City of
Peterborough

Committee of Adjustment Report for September 8, 2021

Staff Recommendations Regarding Files: A36/21, A38/21, and A40/21

Title: SITE SKETCH

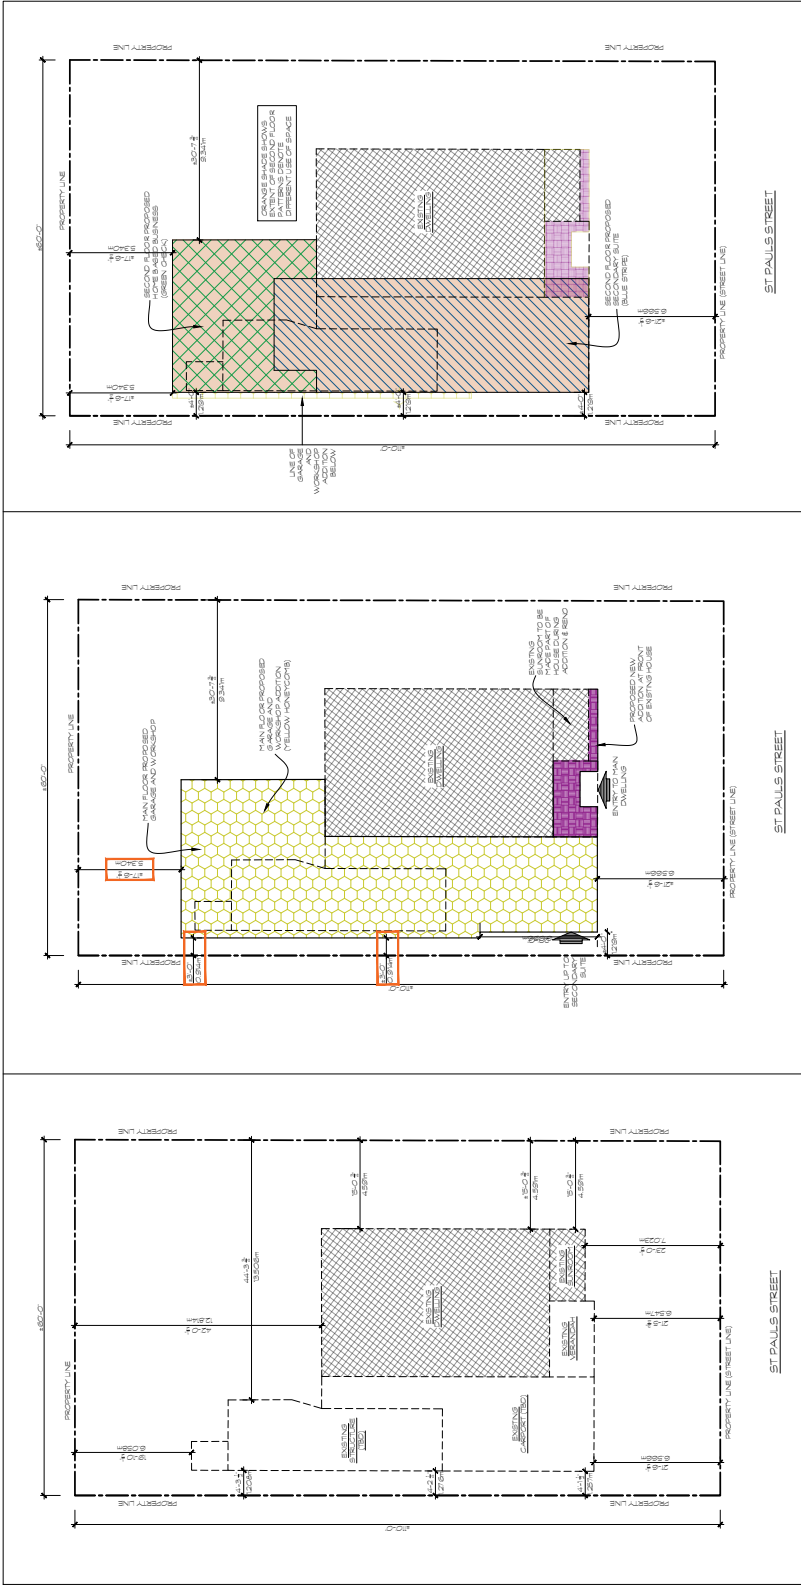
Additionally, the roof of the existing dwelling will be removed, and an upper terrace space will be established. Since the original submission, the applicant has revised the design to increase the separation of the first storey from the south side lot line from 0.61 metres to 0.914 metres (Exhibit A). The second storey will continue to meet the 1.2 metre setback.

The applicant has met the 1.2 metres side yard setback from the west side of the dwelling for the first 6 metres from the front face of the attached garage, jogging to 0.914 metres to accommodate additional interior space within the garage/workshop. The second storey addition is offset to meet the 1.2 metre setback from the side lot line. It is proposed that the rear lot line setback be reduced to 5.34 metres to facilitate the construction of the rear portion of the attached garage and second storey addition.

With respect to the relief sought from the **side yard setback**, staff are of the opinion that the proposed 0.914 metre setback for the two-storey addition will impede the ability for the south/west portion of the property to be appropriately maintained without trespass issues with the neighbour at 1075 St. Paul's Street. This neighbourhood does not have existing instances of permitted encroachments of the main dwelling into the side yard setback. Any previous requests of the Committee have dealt with detached accessory structures (typical relief to 0.5 metres instead of 0.6 metres) and/or a carport (typical relief of 0.6 metres). It is noted that the second storey will be offset to meet the full 1.2 metres, however, from a practical standpoint (i.e., placement of a ladder to access that side of the dwelling) the reduced first storey setback will result in access issues.

With respect to the relief sought from the **rear yard setback**, the plans provided depict that the garage/workshop space will occupy the ground level of the addition and the home-based business will occupy the second storey. The applicant has proposed that any windows facing the neighbours to the west or south would be clerestory in placement and type (located high on the wall) to mitigate overlook issues with these neighbours. There is a large mature deciduous tree located at the rear of the property at 1120 Barnardo Avenue that serves as a mitigating factor.

- There is no site plan registered to the property.
- Given the context of the neighbourhood, the required 1.2 metre side yard setback seems more appropriate than the proposed reduction. The request for a reduction of 0.914 metres would be generally acceptable.
- No concerns with the proposed rear yard setback.

With respect to the relief sought for the reduction in the side yard setback, staff recommend that the committee **deny** the minor variance on the basis that it does not meet the general intent and purpose of the Zoning By-law.

With respect to the relief sought for the reduction in the rear yard, staff recommend that the Committee of Adjustment **approve** the minor variance provided that:

- a) The addition is constructed substantially in accordance with the concept plan attached as Exhibit A. Any minor variances that may appear on these plans but are not listed in the written decision are not authorized.
- b) Any new windows along the west and south façade of the addition be clerestory (high in the wall) to mitigate overlook impacts, similar to the proposal in Exhibit A, page 4.

Title: PRELIMINARY PLANS

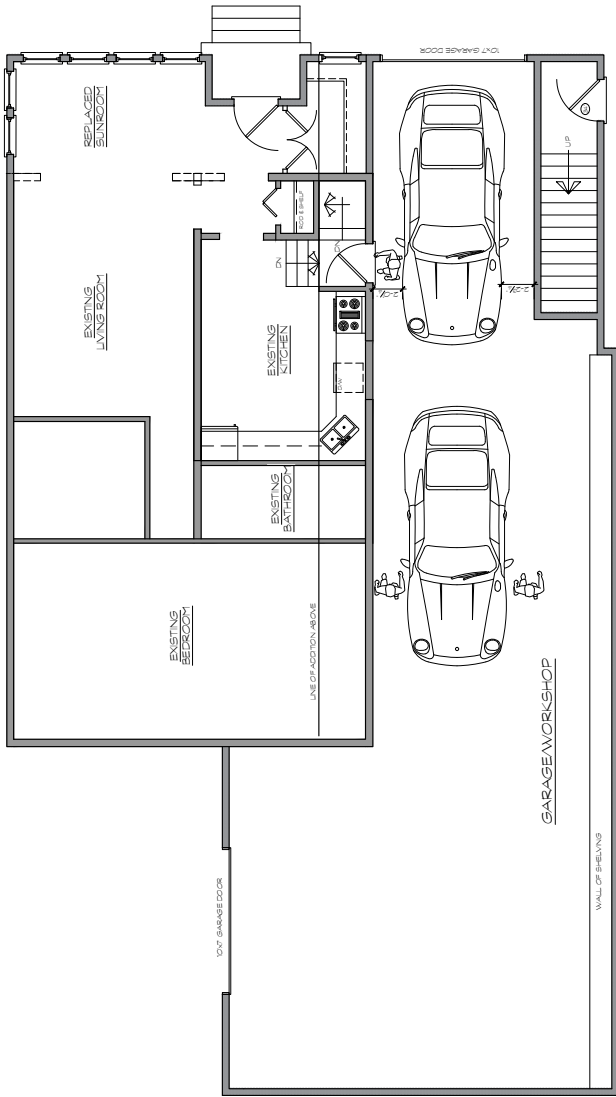
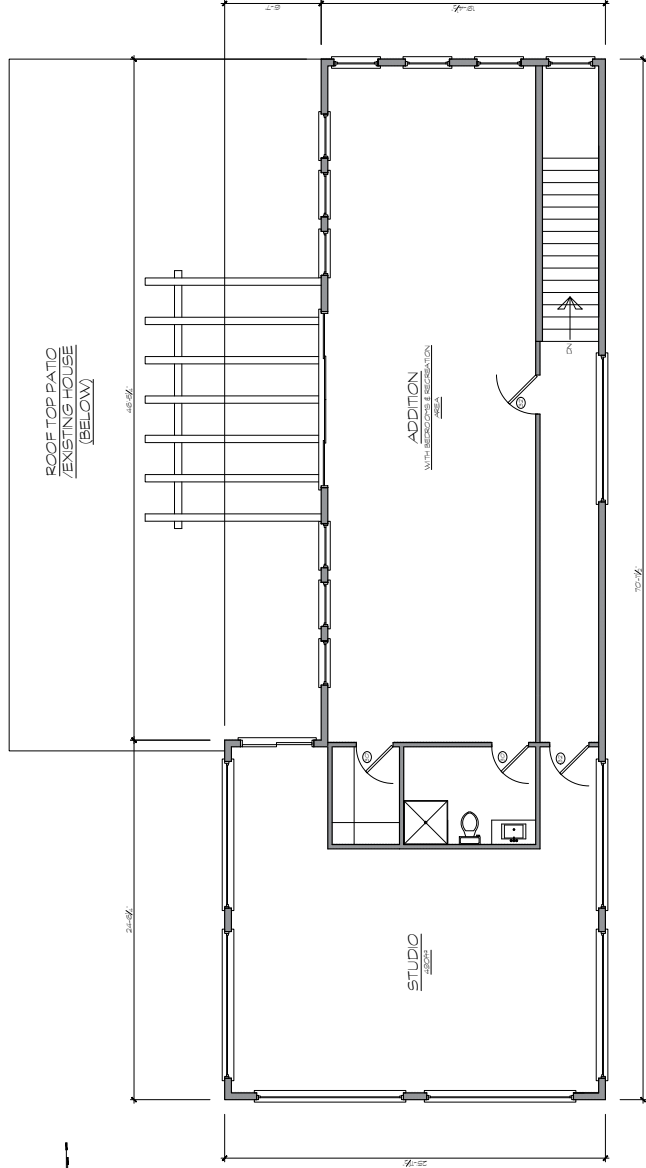
In consideration of the preliminary interior plan for the garage/workshop, staff have reviewed the interior space and a sufficient width can be accommodated for one vehicle parking space (2.7 metres in width) plus additional space (approximately 1.8 metres) for maneuvering and storage. Staff are of the opinion that with respect to the relief sought from the side yard setback for the magnitude of construction proposed, that the request does not meet the general intent and purpose of the Zoning By-law and would not result in desirable development of the land.
